Enquiries to	Nick Gammer	My reference	6/3/9/263
Direct Line		Your reference	F/23/96631
Date	3 rd September 2024	Email	Nick.gammer@hants.gov.uk

Re: One Horton Heath, Internal Distributor Road

Construction of an internal distributor road and associated footways, cycleways, lighting, landscaping and SuDS basins, and diversion of Public Rights of Way footpaths FOHHF 701 and 702 as part of the One Horton Heath development.

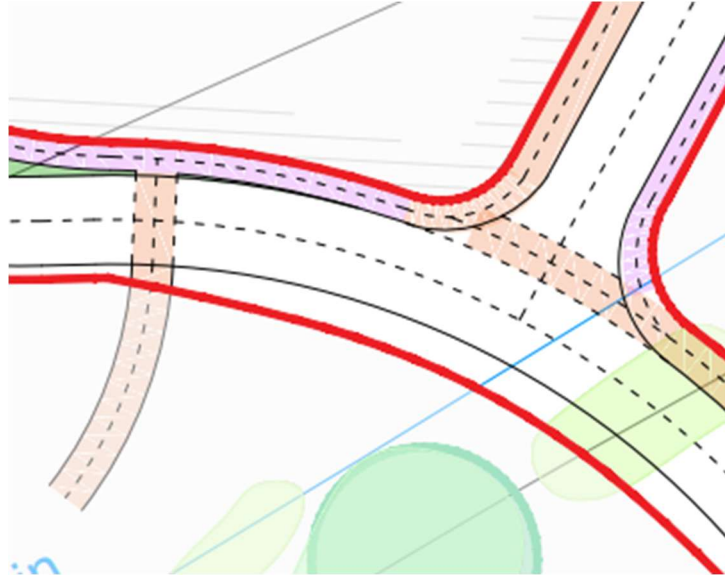
Both Zebra Crossings adjacent to the school site are linking cycle routes either side. The intention now appears that these allow cycle use, however, they are still shown as a standard Zebra crossing layout, rather than a Parallel crossing, which should be addressed.

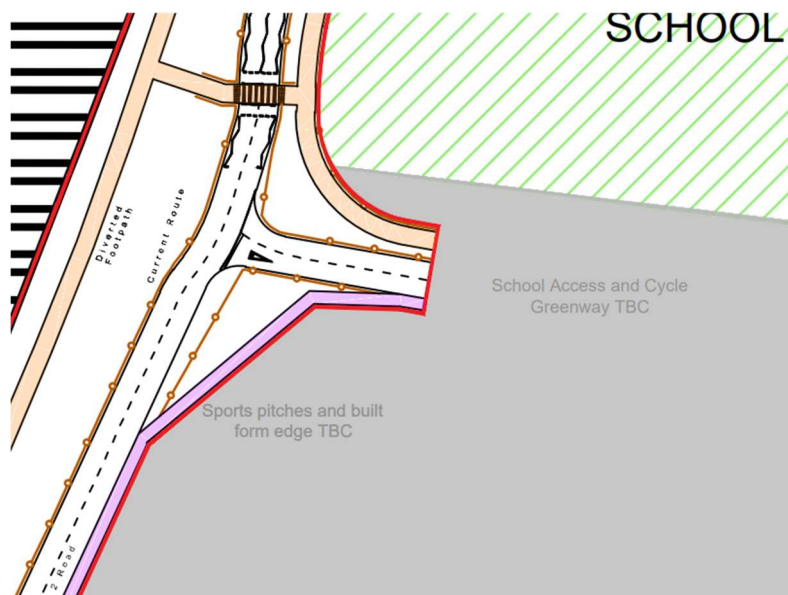
A missing section of shared use foot and cycleway on the northern side of the internal distributor road between the junction linking north to Fir Tree Lane and the pedestrian and cycle route south, just to the west of the junction, was noted previously. This section is still missing and should be amended. It is also unclear what form of crossing is being proposed here, this should be clarified and it will clearly need to accommodate cycles.

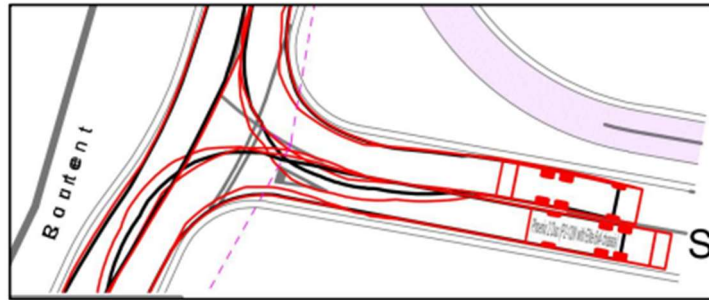
- Drawing 5018551-RDG-XX-ST-DR-C-2213 shows overhang of a bus into the opposite lane at the bend north of the school. Likewise, drawing 5018551-RDG-XX-ST-DR-C-2202 Rev P01 shows a similar overhang issue for a refuse vehicle.
- The zebra crossings on drawing 5018551-RDG-XX-ST-DR-C-2202 Rev P01 are overly constrained for two large vehicles passing. These should be re-assessed and realigned or widened.
- As demonstrated in the extract below, there is overhang of a refuse vehicle into the opposing carriageway when entering the school access road. Given this movement will be infrequent this may be acceptable; however, confirmation of forecast total vehicular movements using this access, and forecast movements of larger vehicles, should be provided for the HA to form a view on the acceptability of the proposed geometry or advise if realignment is required.

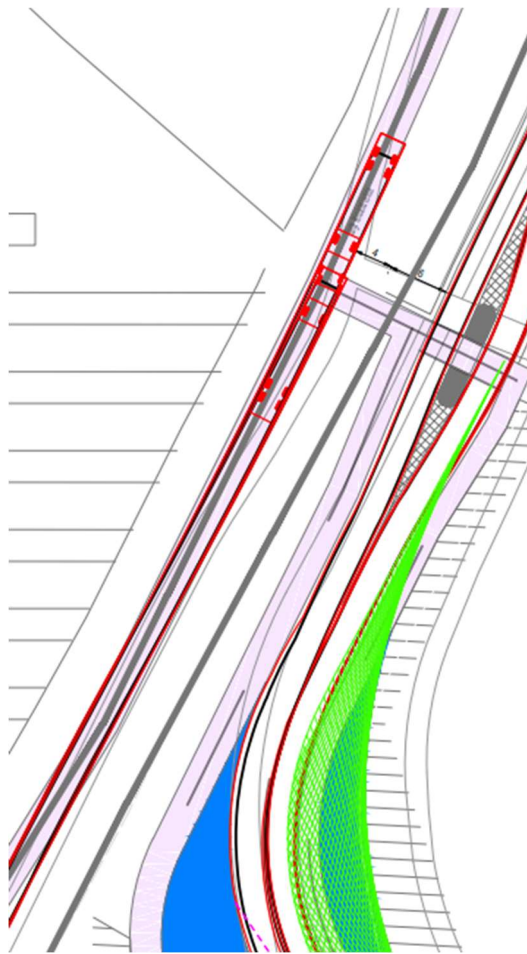
- A bus should be tracked for the junction and carriageway north towards Knowle Lane, given, as previously agreed with the HA, this link should be able to accommodate bus use. Also, initial correspondence from Go South Coast has noted that this link is important as it is the only way bus services diverted into the site can continue to serve existing Horton Heath residents.
- Clarity should be provided regarding why tracking of a refuse vehicle is shown on a proposed shared use foot and cycleway (extract below). This is assumed to be an error, however there would clearly be concern if vehicular use of this path is proposed.
